V2500-A1/A5 SERIES PROPULSION SYSTEMS SERVICE BULLETIN

This document transmits the Revision 2 of Service Bulletin V2500-ENG-72-0590.

ENGINE – CASE ASSEMBLY, TURBINE EXHAUST – REPLACEMENT OR MODIFICATION TO INCREASE N1
MARGIN AND IMPROVE PERFORMANCE DURING TAKE OFF

FIGURE 1, SHEET 1

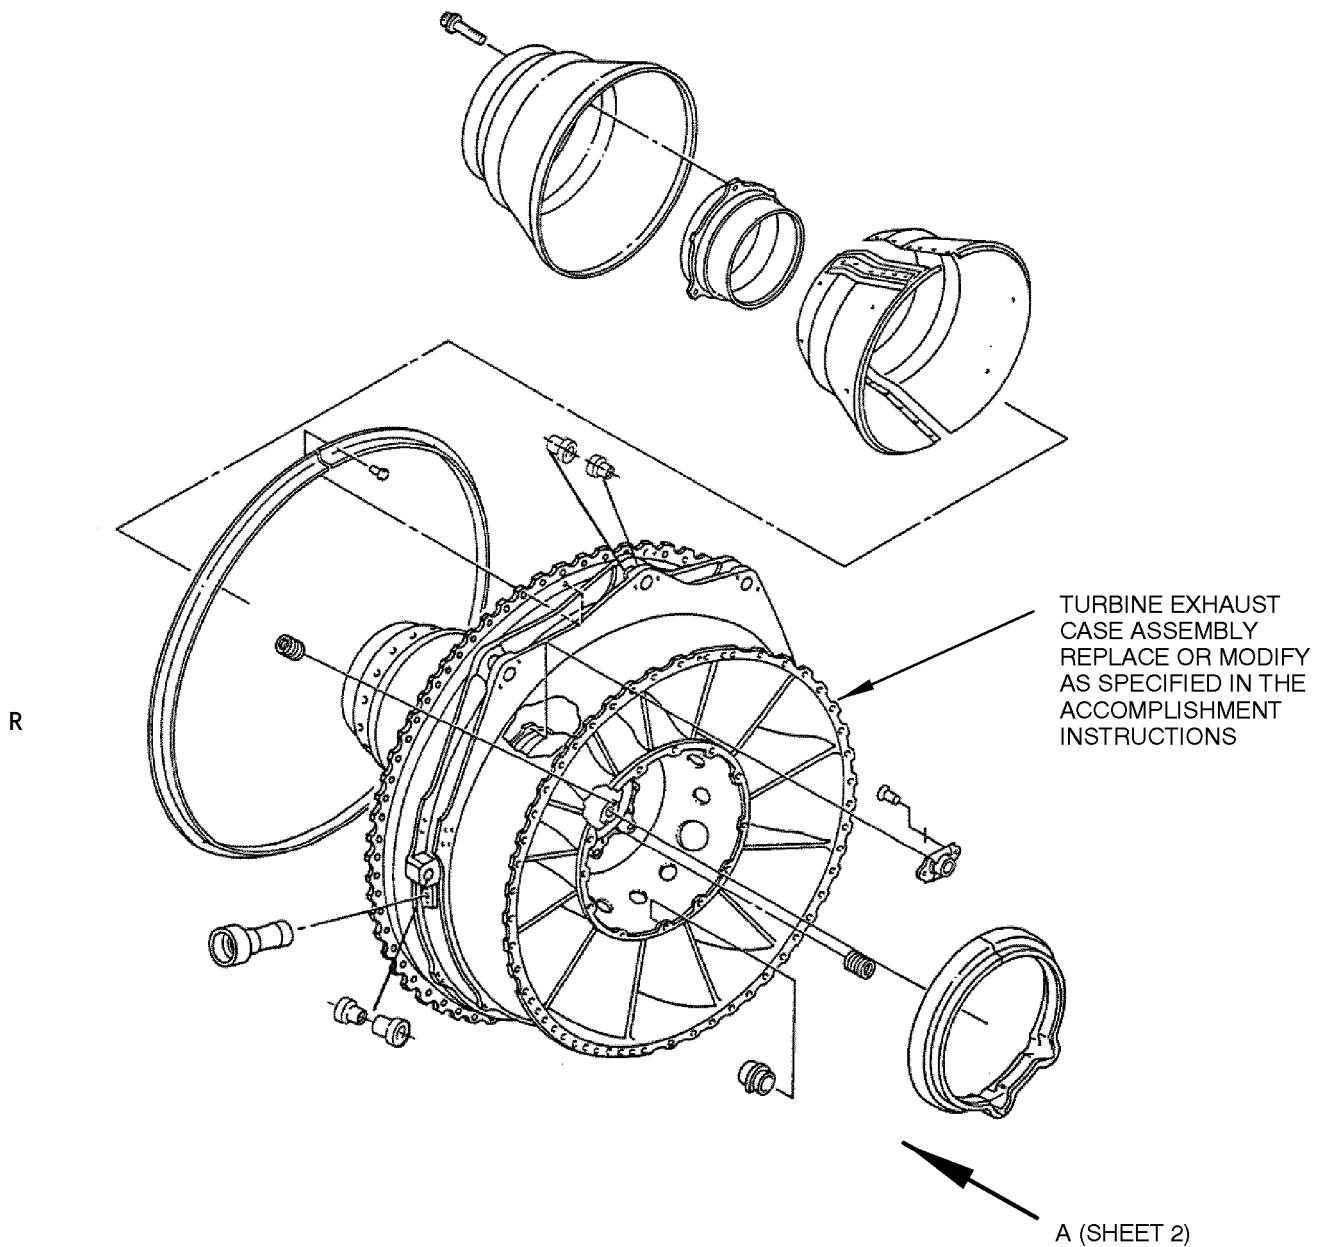
- R (1) Replace the turbine exhaust case assembly as given in the Table 1 below. See Figure 1, Sheet 1.
- R (2) Identify the turbine exhaust case group and turbine exhaust case assembly as given in Table 1 below. Mark the new part number as specified in Reference 9, Standard Practices Manual, Chapter/Section 70-09-00, vibro-peen method. Mark the part number in the same location of existing part number and maintain the same serial number. See Figure 1, Sheet 2 for the location of marking.

LOCATION AND MODIFICATION OF THE TURBINE EXHAUST CASE ASSEMBLY
FIGURE 1, SHEET 2

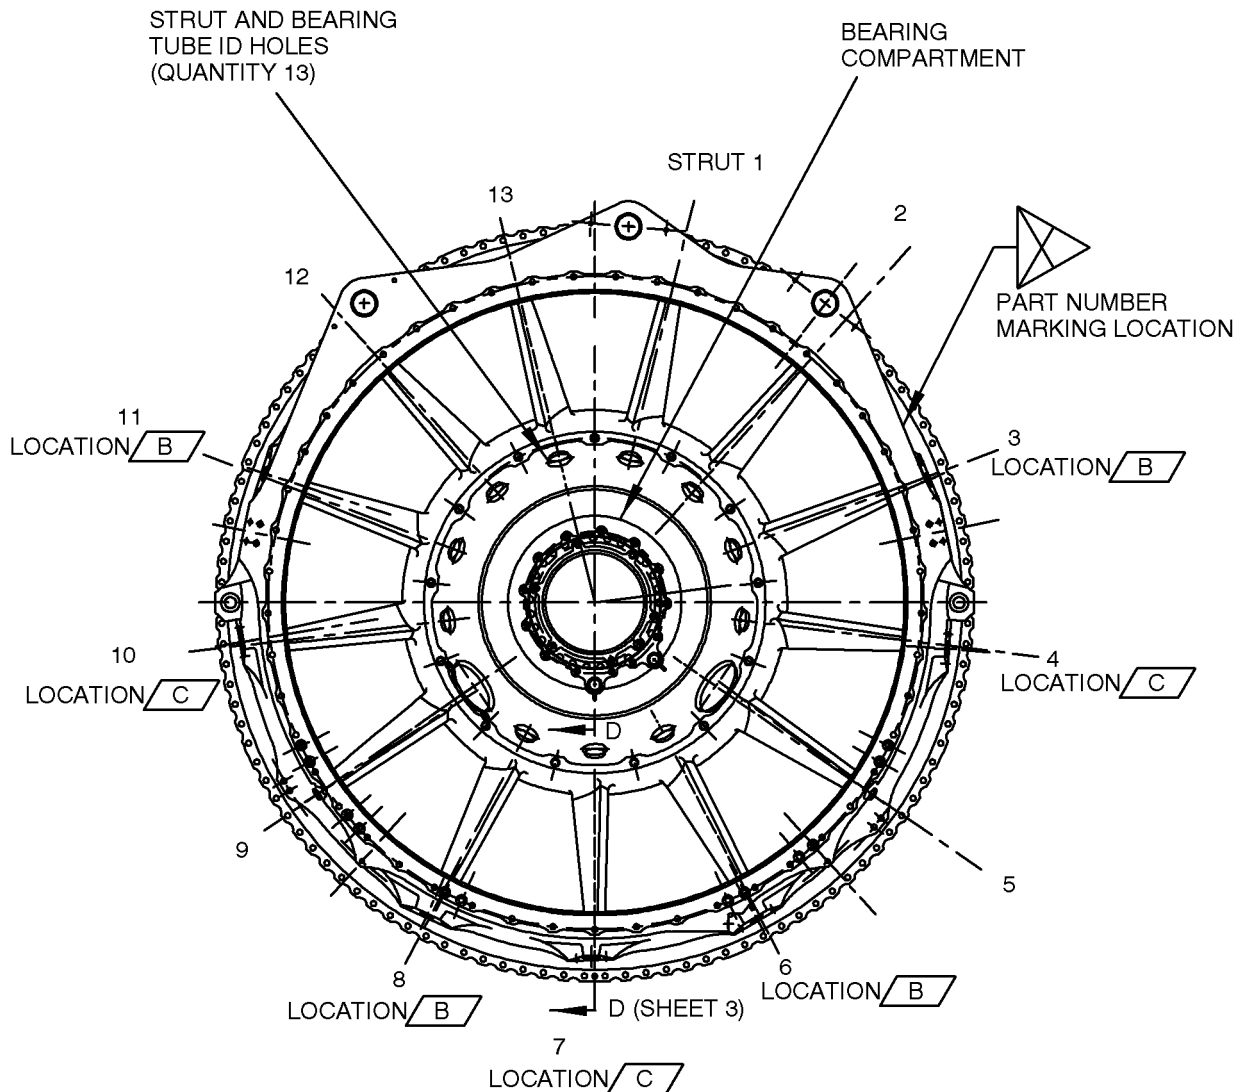
- R (a) Mask the bearing compartment, the bearing tube Inside Diameter (ID)
R holes at Struts 5 and 9, the ID holes at Struts 1 - 13 and Struts 3,
R 6, 8 and 11 at Location B in Figure 1, Sheet 2 to prevent
R contamination from machining operations. Use mechanical covers and
R tape. See Reference 9, Standard Practices Manual, TASK
R 70-38-24-300-503, Mask the Parts 03.

- R (b) Machine to remove material from 24 pressure kiel taps to 0.000 - 0.020
R in. (0,00 - 0,51 mm) above the strut leading edge on Struts 4, 7 and
R 10 at Location C in Figure 1, Sheet 2. Do not remove strut parent
R material.

- R (ii) Insert the borescope through the external bosses on the case at
R Location C (three locations) in Figure 1, Sheet 2.
- R (iii) If you find machining chips or coolant, then clean the TEC
R again by the procedure in Reference 9, Standard Practices
R Manual, TASK 70-11-03-300-503, Aqueous Degrease 03. Thoroughly
R flush all cavities, strut openings and the bearing compartment.

- (p) Identify the turbine exhaust case group and turbine exhaust case assembly as given in Table 2 below. Mark the new part number as specified in Reference 9, Standard Practices Manual, Chapter/Section 70-09-00, vibro-peen method. Mark the part number in the same location of existing part number and maintain the same serial number. See Figure 1, Sheet 2 for the location of marking.

LOCATION AND MODIFICATION OF THE TURBINE EXHAUST CASE ASSEMBLY
FIGURE 1, SHEET 3

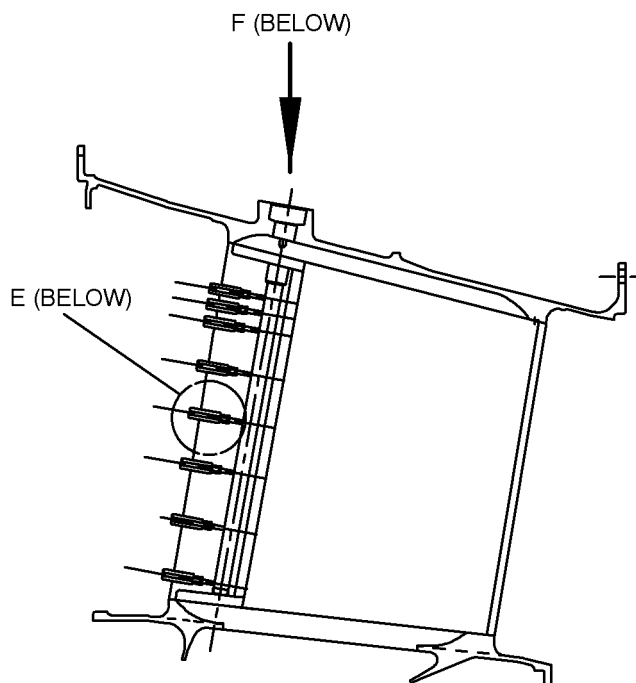
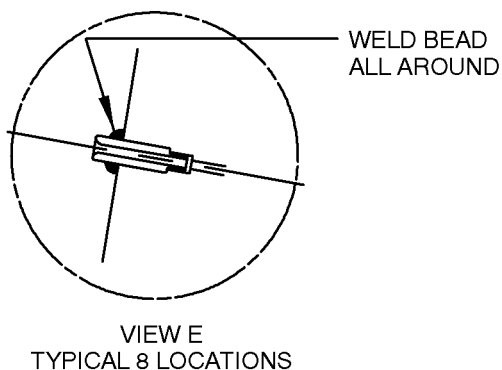
- R **CAUTION:** ATTACH A GROUNDING CLAMP TO STRUT BEING WELDED TO PREVENT ARCING
R ACROSS BEARING FEATURES.
- R (m) Assemble and weld the 24 new Pressure Kiel Taps, PN 2A4257 into the
R struts 4, 7 and 10 (Location C). Use the Gas Tungsten Arc Weld (GTAW)
R procedure and Welding Wire, COMAT 03-378, except theoretical throat
R requirement is waived, actual throat must be 0.020 inch (0,508 mm)
R minimum. Refer to Reference 9, Standard Practices Manual,
R Chapter/Section 70-31-13. See Figure 1, Sheets 3 and 4.

LOCATION AND MODIFICATION OF THE TURBINE EXHAUST CASE ASSEMBLY
FIGURE 1, SHEET 4

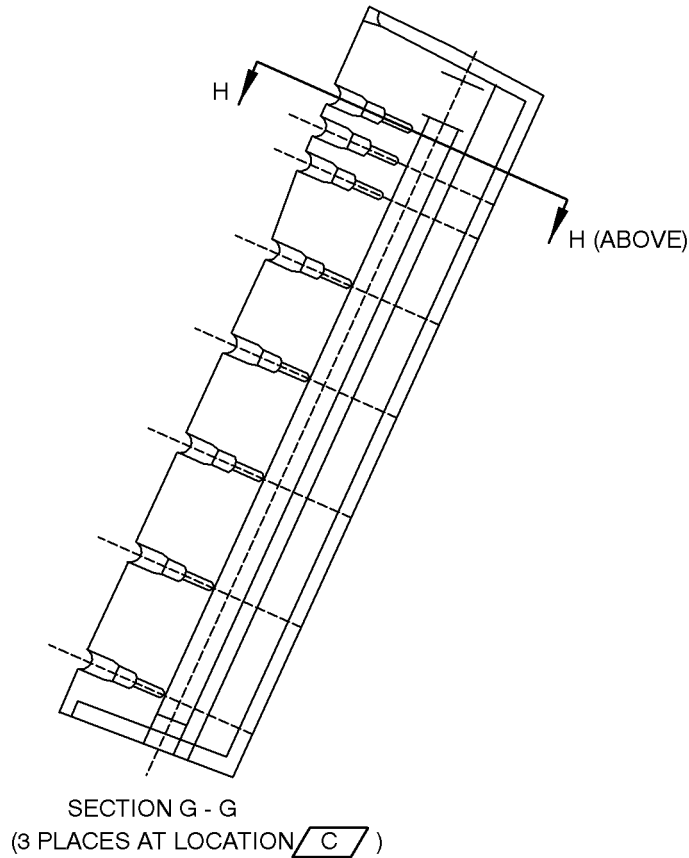
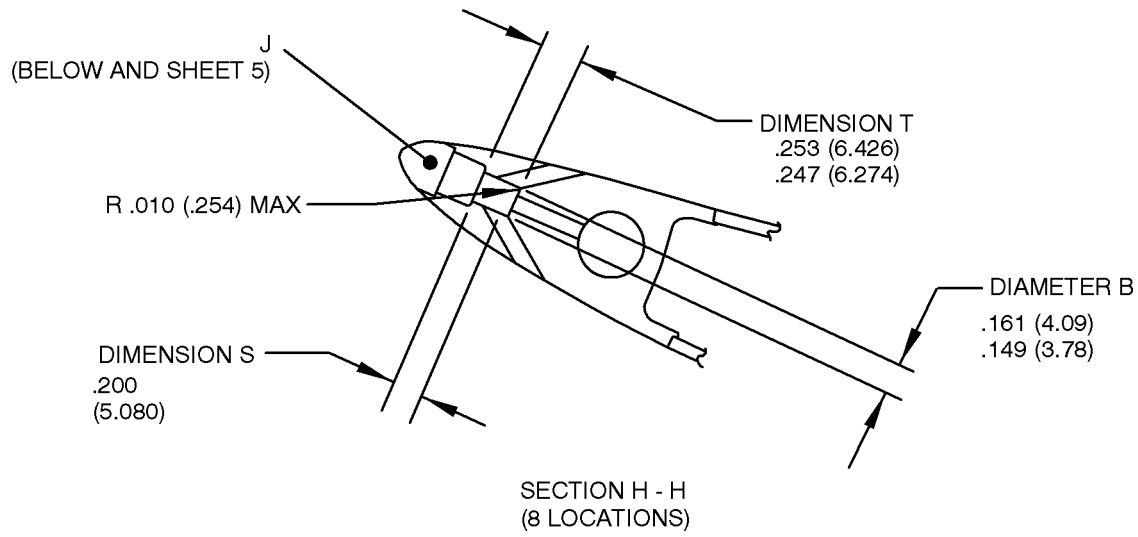
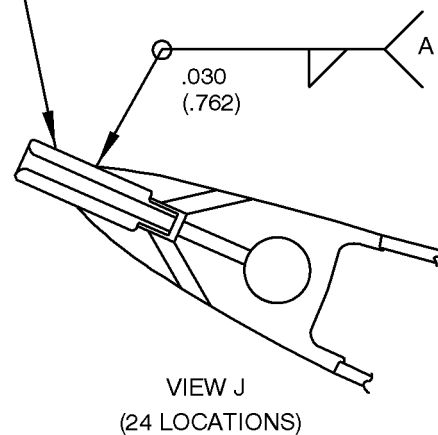
- R (h) Machine Diameter B to extend the length from Dimension S, 0.200 in.
R (5,080 mm) to Dimension T, 0.247 – 0.253 in. (6,274 – 6,426 mm) at 24
R locations. A 0.002 in. (0,051 mm) step is permitted between lengths
R Dimension S and Dimension T. See Figure 1, Sheet 4.

LOCATION AND MODIFICATION OF THE TURBINE EXHAUST CASE ASSEMBLY
FIGURE 1, SHEET 5

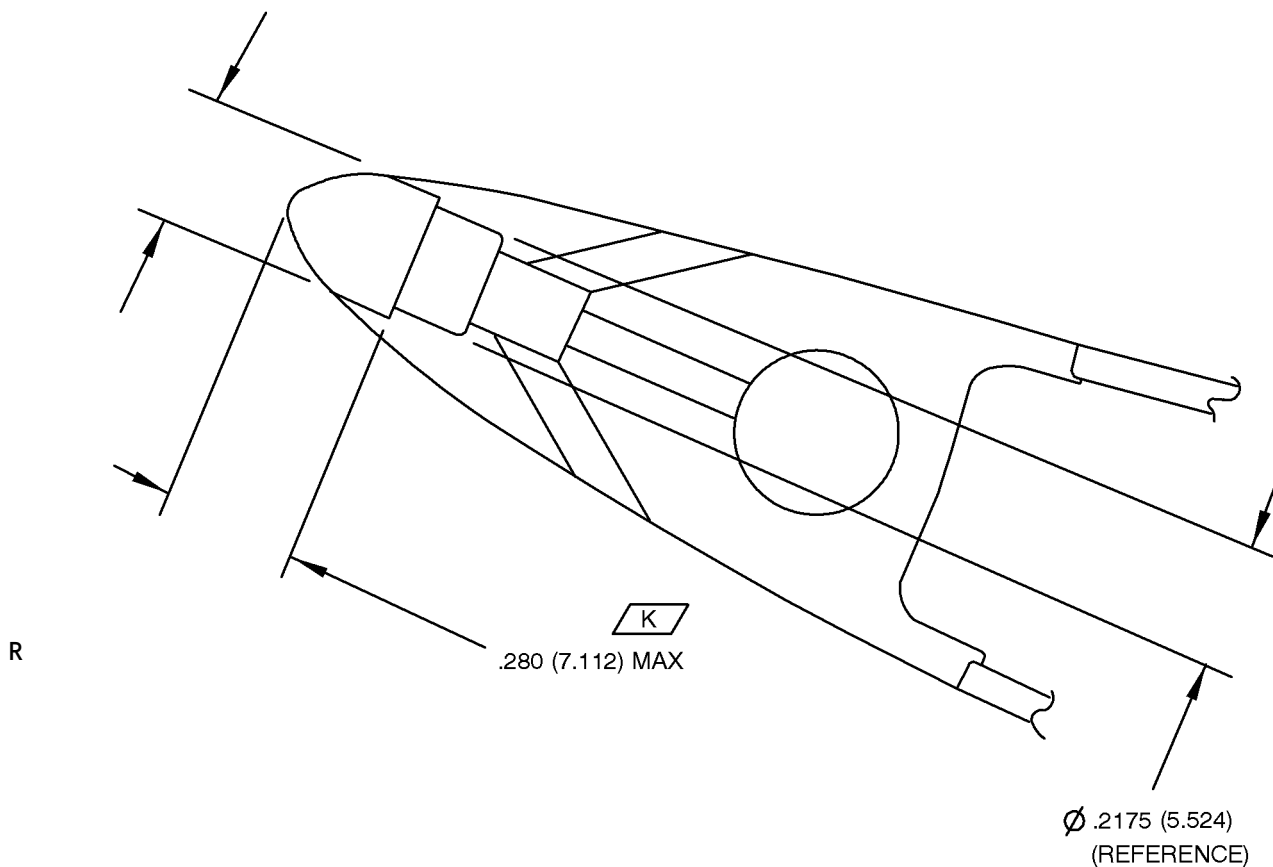
- R (e) Partially remove the 24 pressure kiel taps by machining a 0.238 in.
R (6,045 mm) diameter hole to 0.280 in. (7,112 mm) maximum depth at each
R pressure kiel tap location. Locate the center of the 0.238 in. (6,045
R mm) diameter hole using the center line of the existing 0.2175 in.
R (5,524 mm) diameter hole. See Figure 1, Sheet 5.

- R (i) Break all edges/corners 0.003 – 0.015 in. (0,08 – 0,38 mm), except as
R shown in Figure 1, Sheet 5.
- R (j) Remove tape and mechanical covers, and remove any residue that remains
R by solvent wiping. See Reference 9, Standard Practices Manual, TASK
R 70-38-24-300-503, Mask the Parts 03 and TASK 70-11-26-300-503, Solvent
R Cleaning 03.
